# **Air Quality Permitting Response to Public Comments**

**Tier I Operating Permit No. T1-2014.0034  
Project 61419**

**Idaho Power Company, Evander Andrews Complex  
Mountain Home, Idaho**

# CLARKE FIRE PUMP DRIVERS

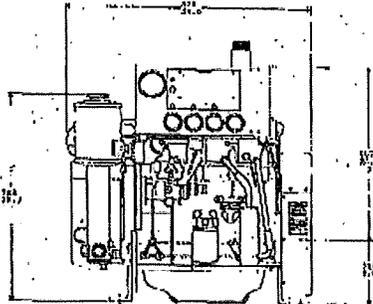
- 1) The emergency diesel fire pump engine in the proposed permit has a rating of 231 bhp, whereas the previous permitted fire pump engine (PTC No. 04-0031) had a rating of 185 hp. This increase in engine power could very well cause an increase in facility-wide PTC, however it does not appear any revised calculations were done. Does the newly installed 231 bhp fire pump engine cause a facility-wide exceedance of 250 tons per year of NO<sub>2</sub>? DEQ should provide justification and calculations to demonstrate that a PSD analysis is not needed.

Looking back many years at previous permits issued to Idaho Power, it appears that the emergency fire pump engine was inadvertently changed from 185 hp to 231 hp with no explanation or revision in emission calculations. DEQ requested that Idaho Power provide the actual engine specifications for the emergency fire pump engine that is rated at 231 hp in the current permit. The engine manufacturer sheet and data plate provided from Idaho Power shows that the engine is rated at 87 hp (as seen in Section 3, attachments). The engine suffered damage in 2006 when it overheated and caught on fire but the damaged parts were replaced on the original engine. The engine has not been replaced since it was originally installed.

In PTC No. P-040031 issued March 18, 2005, the fire pump engine was listed at 185 hp with appropriate emission calculations. The actual engine is only 87 hp, hence the emissions are overestimated and therefore there has not been an emission increase that would have justified the need to do a PSD analysis at the facility. The correct engine rating of 87 hp will need to be changed in an underlying PTC revision.
